Feasibility and Repeatability of the Sled Test in AECS-Annex 7

12th AECS meeting

09-11 Feb 2016

Proposed amendment corridor

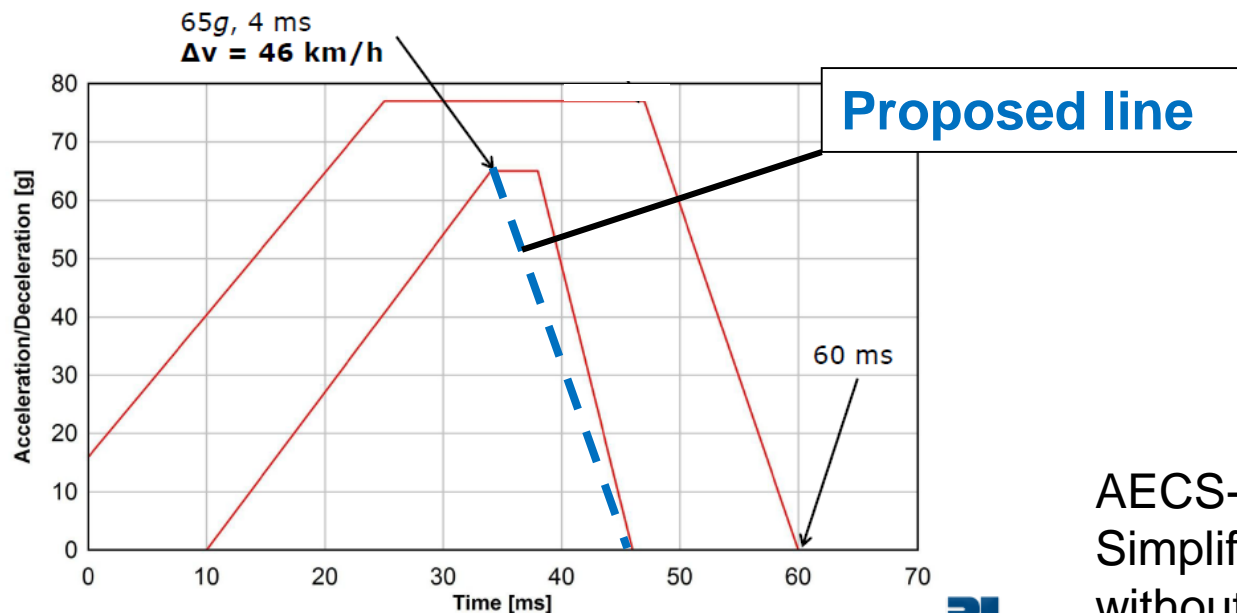
- It is necessary to propose **minor amendment for rapid deceleration** in the current corridor that can mitigate the damage of the accelerated-type sled device.

■ Japanese proposition: a dashed line in the figure.

- This will give more freedom to the test pulse form.
- Therefore, this can mitigate a possibility of damage to the brake system of accelerated-type sled device.
- Maximum acceleration 65 G of the lower corridor is kept as TRL proposal.
- The velocity change ΔV 68-70 km/h is kept.
